**POCATELLO CITY COUNCIL
PUBLIC HEARING: FEBRUARY 6, 2025
EXECUTIVE SUMMARY**

PROJECT: Aspen Place Planned Unit Development
APPLICANT/OWNER: David Assan of Sunrise Engineering -representing Gate City Builders
SURVEYOR/ENGINEER: Matt Baker of Sunrise Engineering
LOCATION: Four separate parcels located at 2806 S. 5th Avenue
FILE: PUD24-0002

Re: Aspen Grove Apartments - P&Z Preliminary Plat (01.08.2025) Application #PP24-0004

SHEET NAME:
PRELIMINARY PLAT FOR:
ASPEN GROVE SUBDIVISION

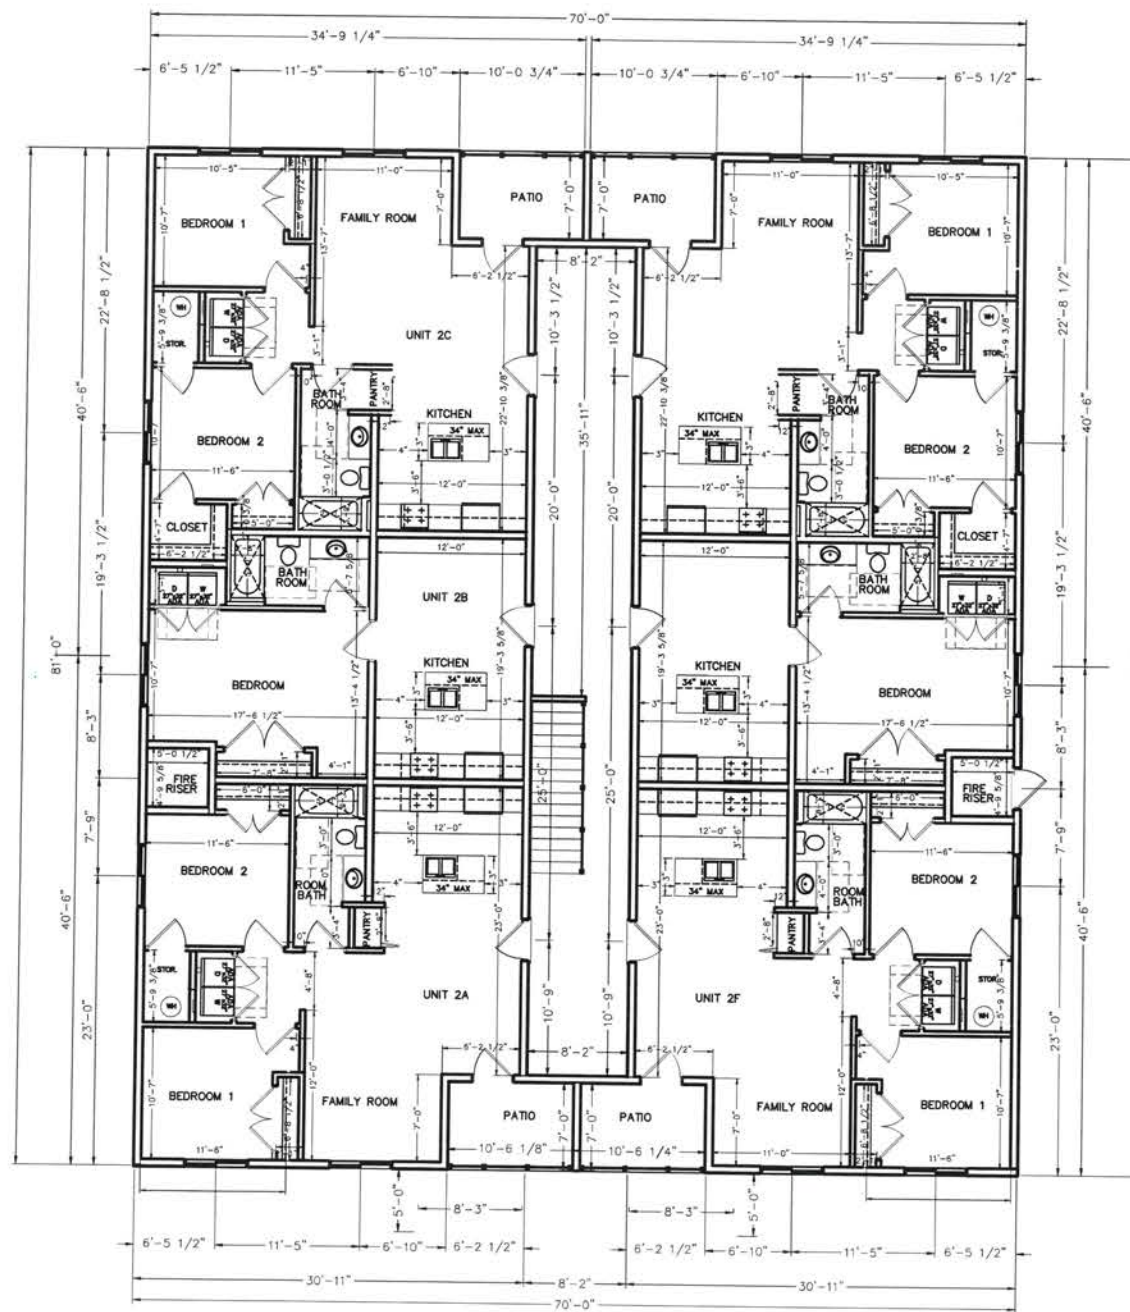
The Public Works Department has reviewed the preliminary plat application for the above-mentioned project and submits that the following changes and items shall be addressed prior to final plat application.

1. Switch the retention pond/snow removal stockpile area with Lot 1.
2. Confirm the center line of the proposed approach is lined up with the center line of Garden Street.
3. A street light shall be added at the proposed approach adjacent to S 5th Ave.

4. A traffic calculation and evaluation will need to be submitted at the time of final application.
5. Landscape trees adjacent to S 5th Ave. shall not incumber sight distance for a 35mph travel speed.

6. Add master meter size, vault and double check valve and vault location and detail to final plan set.
7. Calculations show there should be a minimum of 10 6-yard garbage dumpsters provided for this development. Dumpsters will be front load and require 60-90-feet of clear space for truck access.

8. The parking area shall be dedicated as shared common area and at no point may any gates or other obstruction be placed within the parking and access area so as to prevent fire access and garbage pickup through the parking lot areas. Fire access will be required to the rear yard of each townhome from the parking area.

9. Place a fire truck turning template for the drive isles within the parking area to insure adequate drivability.
10. Above ground communication line parallel to S 5th Ave. will need to be relocated underground through this development.
